Annex I of TPB Paper No. 10176

Representation to the Draft Tung Chung Extension Area Outline Zoning Plan No. S/I-TCE/1 under Section 6(1) of the Town Planning Ordinance

**Representation to the Draft Tung Chung Extension Area Outline Zoning Plan
No. S/I-TCE/1**

Figure 15. Mudflat and mangrove habitats covered by the proposed Regional Open Space (RO) zone under the RODP – TCW.

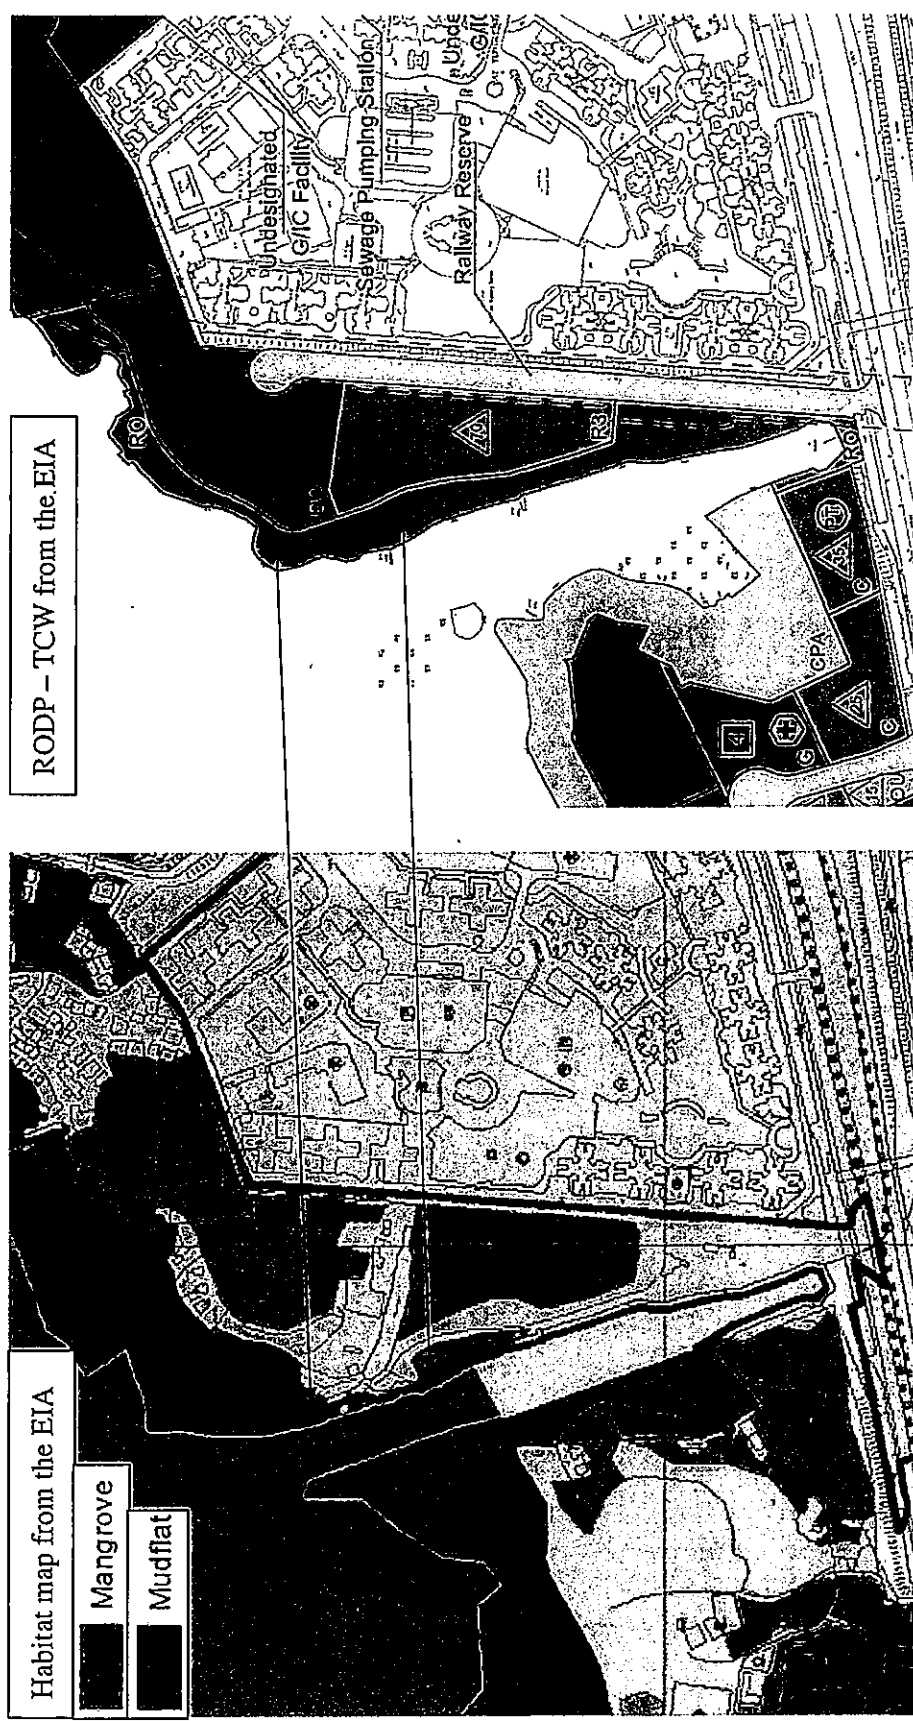
5.3 There are mudflat and mangrove habitats covered by the proposed Regional Open Space (RO) zone under the RODP – TCW (Figure 15). However, it is not obvious or clear from the habitat loss estimation documented in Table 9.29a of the EIA that there is any provision for loss of mangrove or mudflat habitat. We would like the applicant to clarify further in the ACE as to how these habitats would be well preserved, and thus, able to guarantee that no losses would appear or occur.

Figure 16. Suspected illegal bridges constructed across Tung Chung streams.

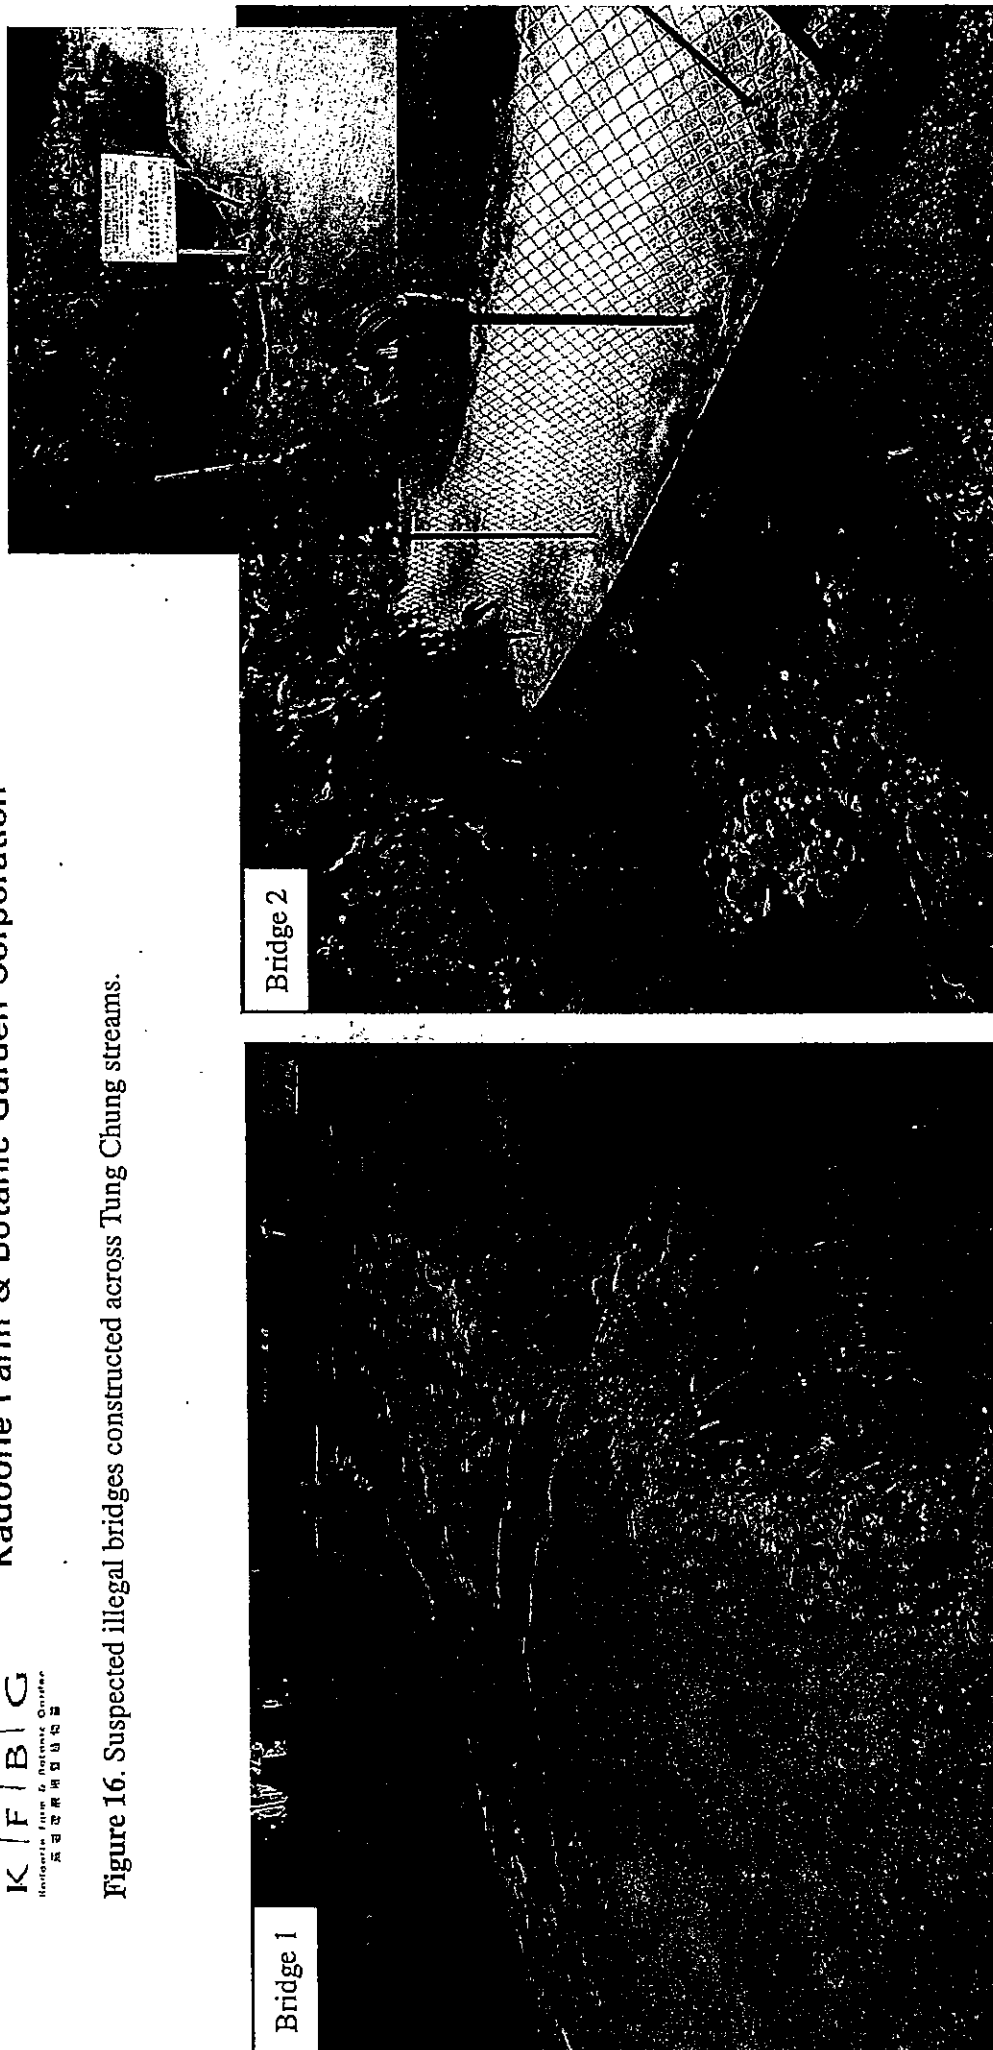
6.1 There are, at least, two suspected illegal bridges crossing the Tung Chung stream tributaries (Figure 16). We have urged the authorities to remove these sub-standard bridges when the New Town in Tung Chung West is in the process of construction. Indeed, various environmental NGOs have already made complaints regarding these bridges for years but so far in vain as no remedial action has been taken to handle this issue. To date, we have not received any response or positive confirmation from the relevant authorities as to whether these bridges would be removed or replaced. The lack of appropriate response is disappointing as these bridges obviously obstruct the flow of stream water and, thus, would affect the passage of migratory aquatic fauna moving throughout the length of these natural watercourses. Furthermore, it would also increase the flooding risk of the area. The Government always claims that Hong Kong is a World Class City. If this is true, we would urge that haphazard vernacular structures of Third World standards should not appear in Hong Kong. We consider that removing these shoddy sub-standard structures is simply what any responsible government agency should do and we urge that the relevant authorities handle this issue in a responsive and responsible manner.
